**ADDENDUM NO. 1**

**PROJECT:** Special Education Alterations to  
Centennial High School  
Williamson County Schools  
J+B No. 2519  
WCS RFB #1408

**ARCHITECT:** Johnson + Bailey Architects, P.C.  
City Center, Suite 700  
100 East Vine Street  
Murfreesboro, TN. 37130

4 POWER & SYSTEMS - CORRIDOR D-9, D-14, TLT. D-18, & T.W.A. D-19  
1/4" = 1'-0"

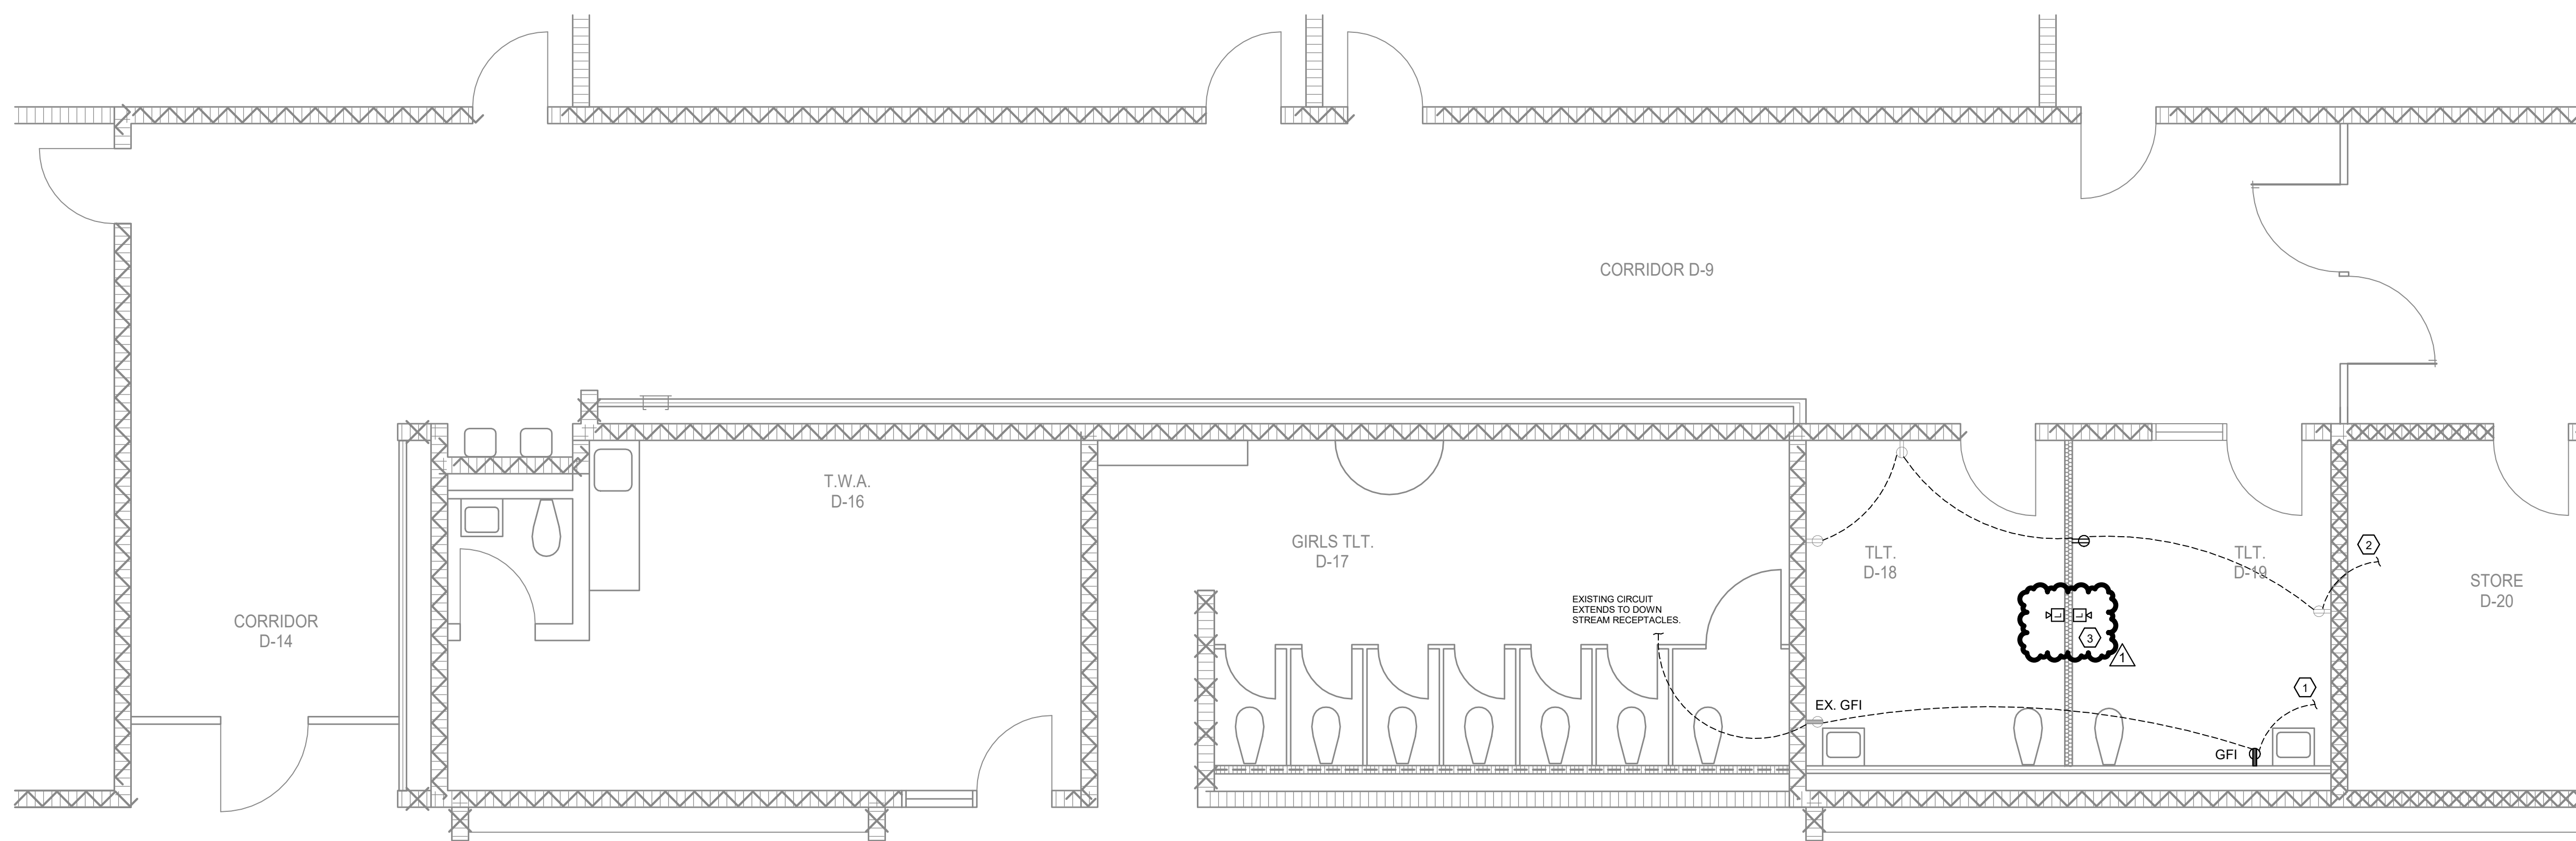
ADD: Fire alarm strobes at TLT. D-18 and TLT. D-19 as shown on the attached revised drawing E201 dated 05/04/26.

1. PROVIDE NEW GFI RECEPTACLE. REWORK WIRING FOR NEW CONFIGURATION TO CIRCUIT IN PANEL LD.
2. PROVIDE NEW RECEPTACLE AND REWORK WIRING FOR NEW CONFIGURATION TO CIRCUIT IN PANEL LD.
3. PROVIDE NEW WALL MOUNTED FA STROBES FOR TOILETS D-18 & D-19. CONNECT TO EXISTING FA SYSTEM.
